March 19, 2021

ADDENDUM NO. 6
TO CONTRACT DOCUMENTS FOR THE
UPPER LLAGAS CREEK FLOOD PROTECTION PROJECT, PHASE 2A
Project No. 26174052 Contract No. C0665

Notice is hereby given to Prospective Bidder that the Contract Documents are modified as hereinafter set forth.

SHEET NUMBER
IR-2A
PAGE 176A OF 179

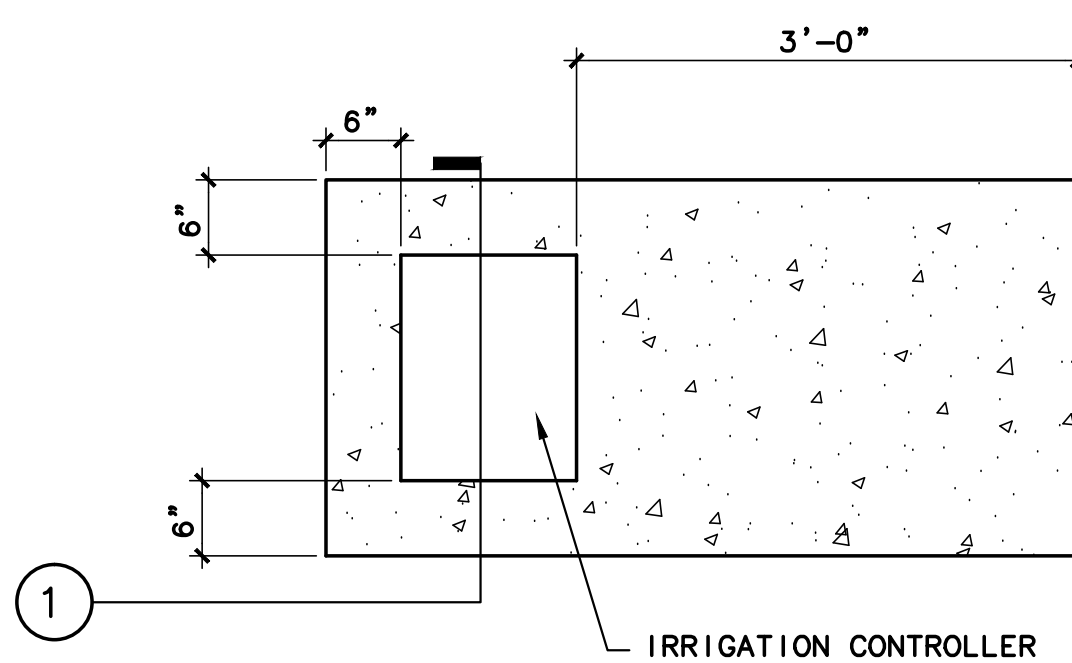
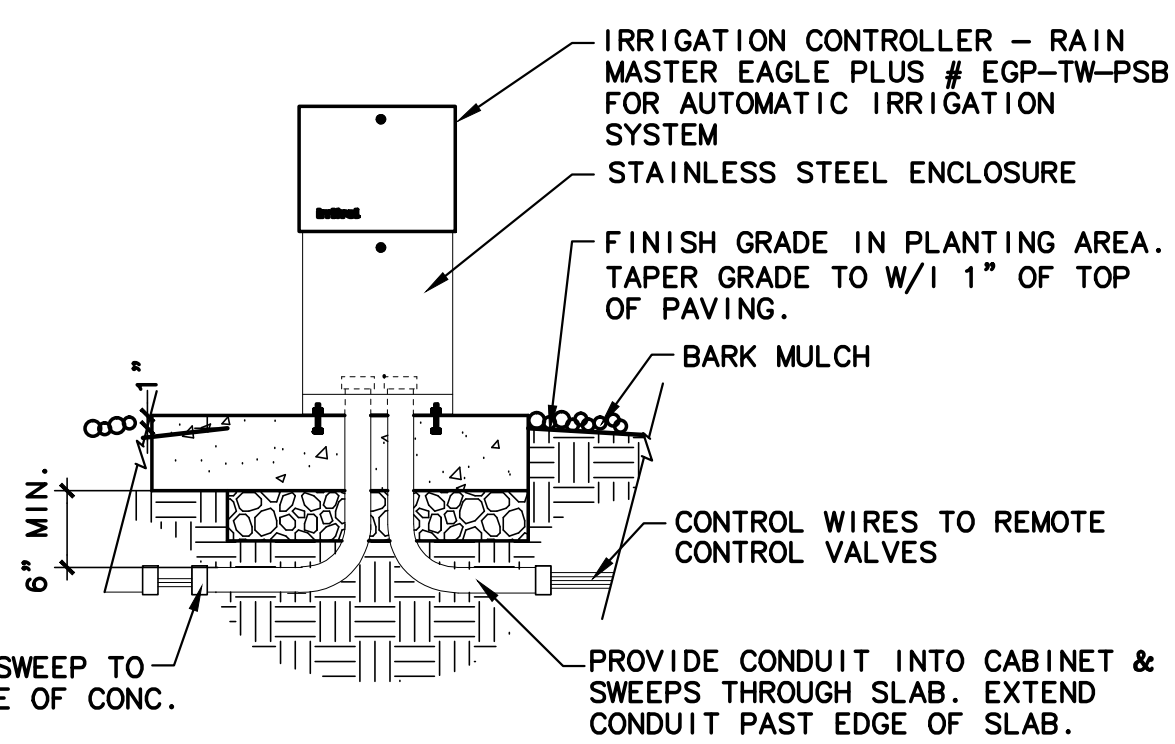
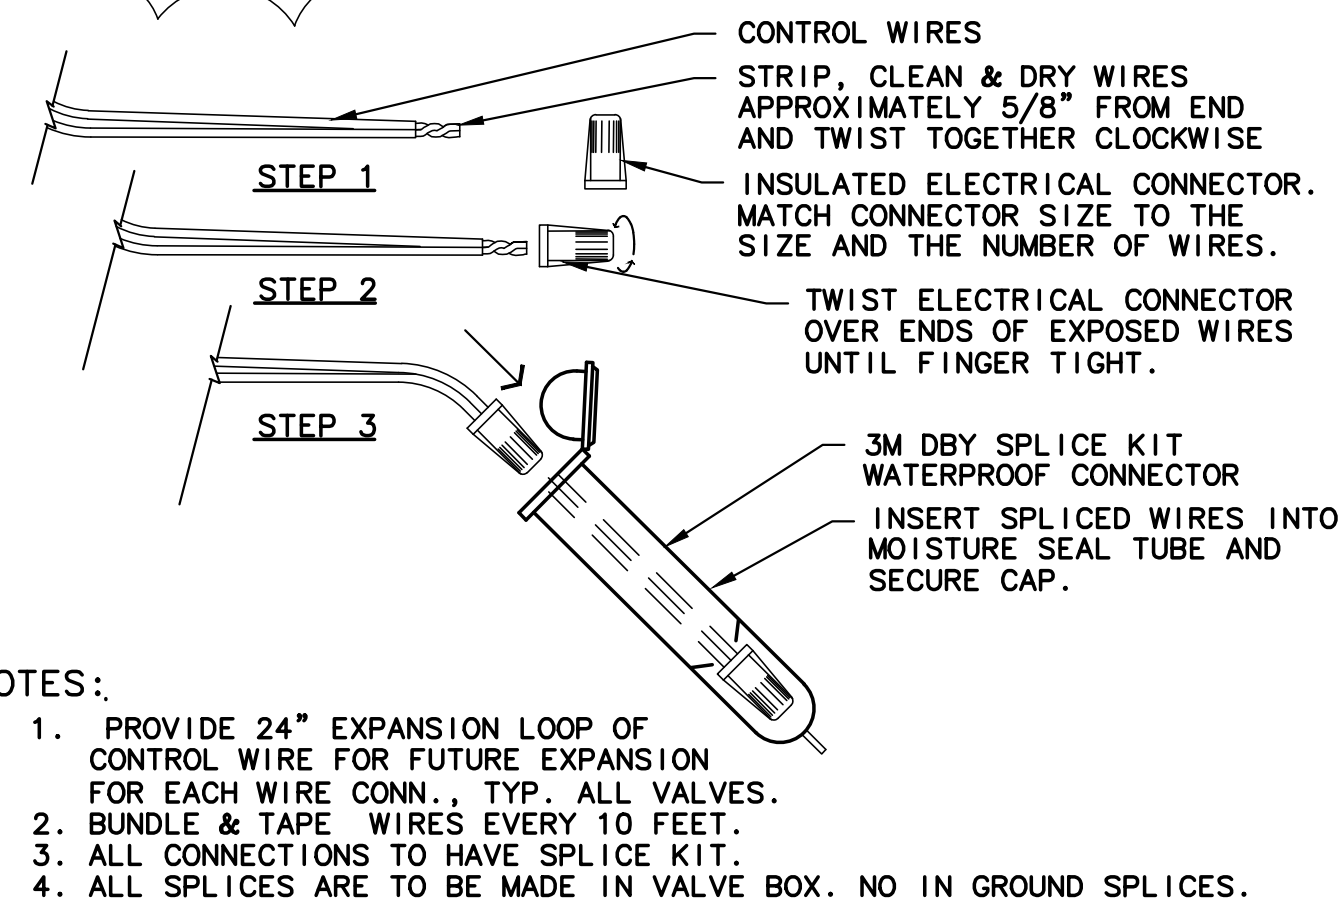
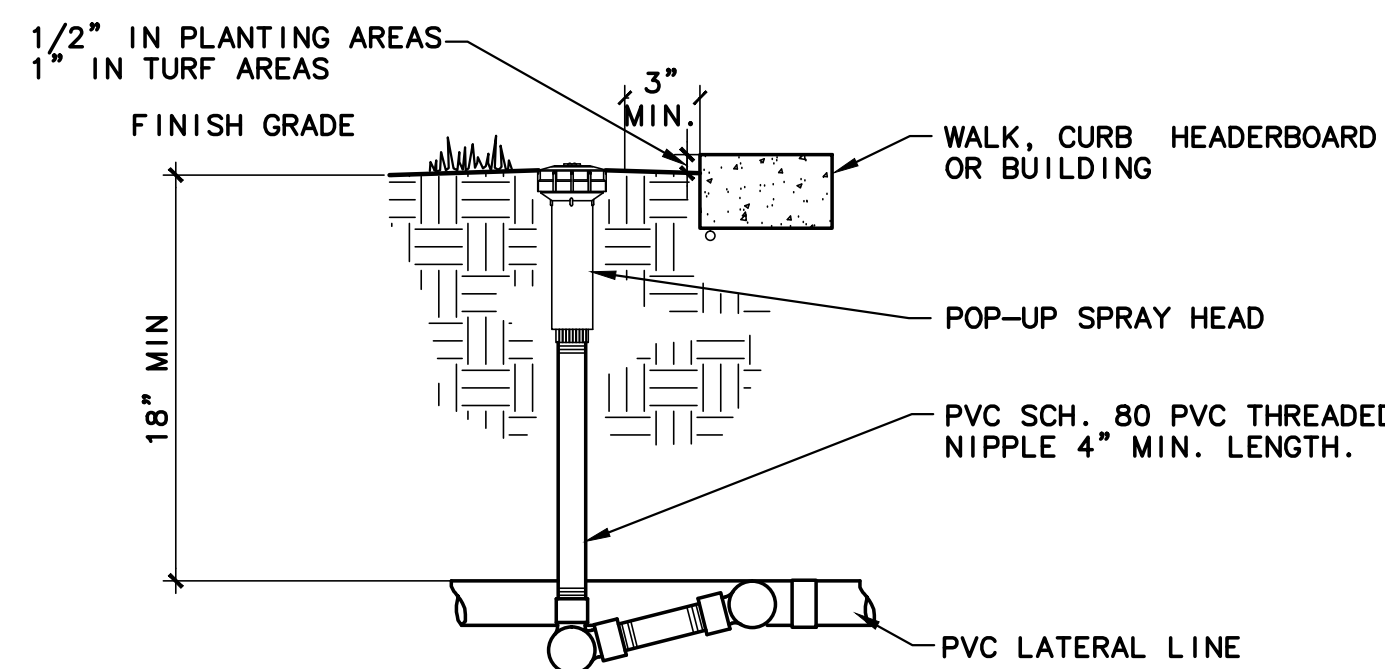
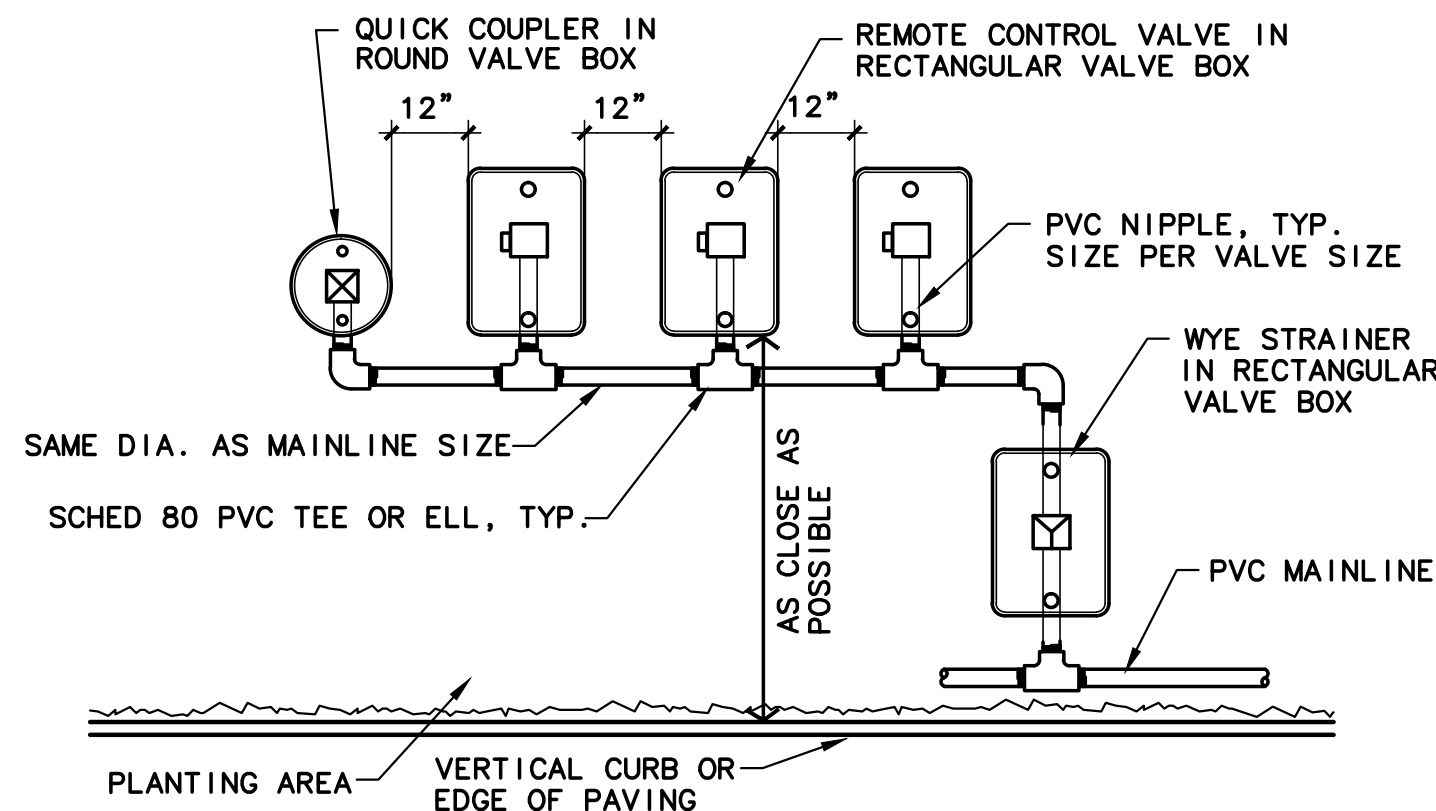
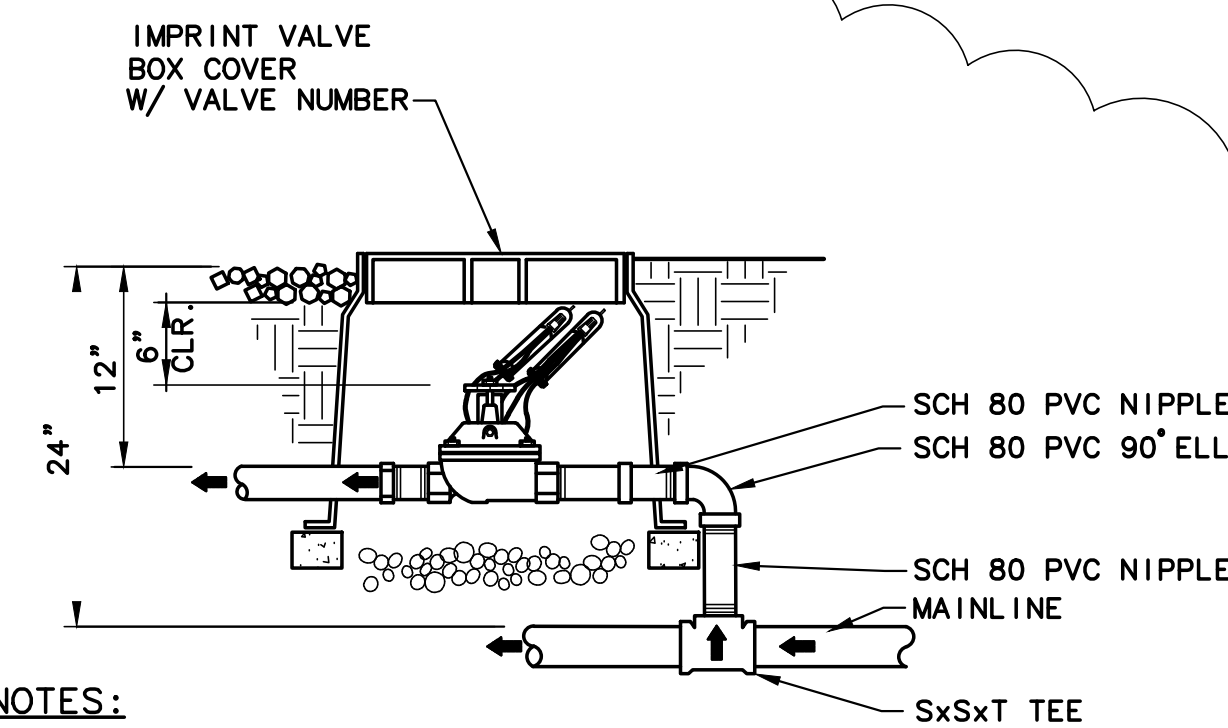
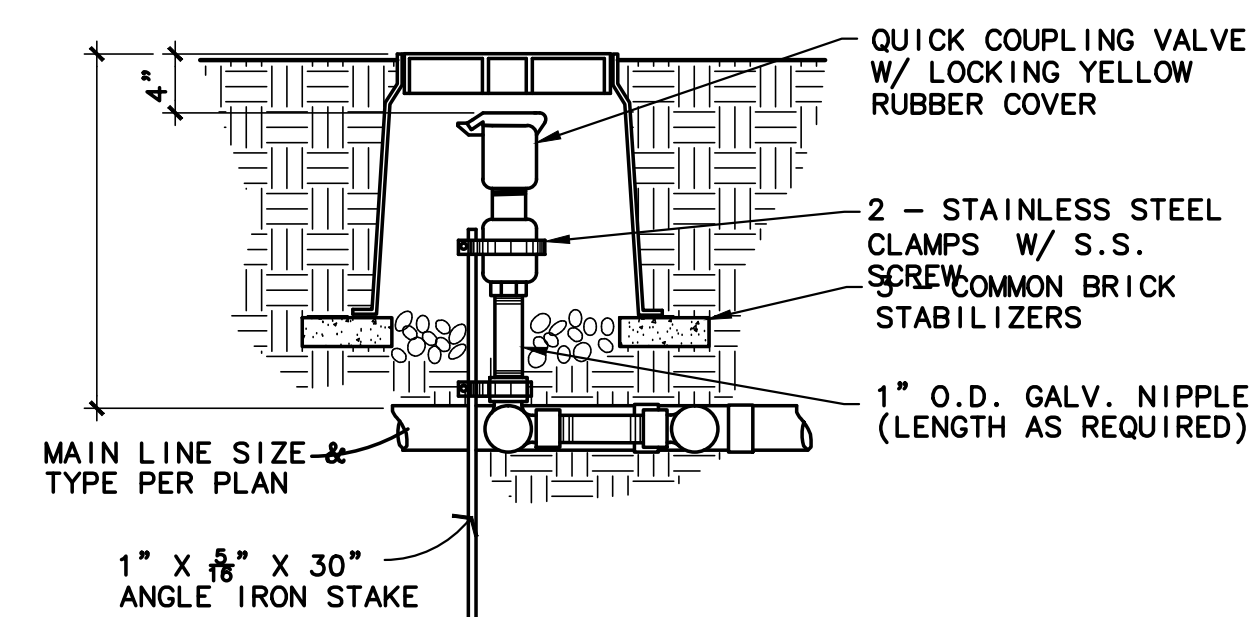
- SCALE: 1” = 20’-0” ”
15. **ADD** new Sheet IR-2A (Page 176A of 179), please see ATTACHMENT NO. 2.
16. **REPLACE** on Sheet PL-1 (Page 177 of 179), Planting Notes, General Planting Information E.2 with the followings:

There is no irrigation detail for the irrigation system shown on sheet IR-1 & IR-2. Please provide.

Irrigation details are shown on the Hale Avenue Irrigation Detail Sheets HAID-1 through HAID-3 (Page 170 to 172 of 179). Additionally, please see new sheet IR-2A (Page 176A of 179) item no. 15 of Addendum No. 6.
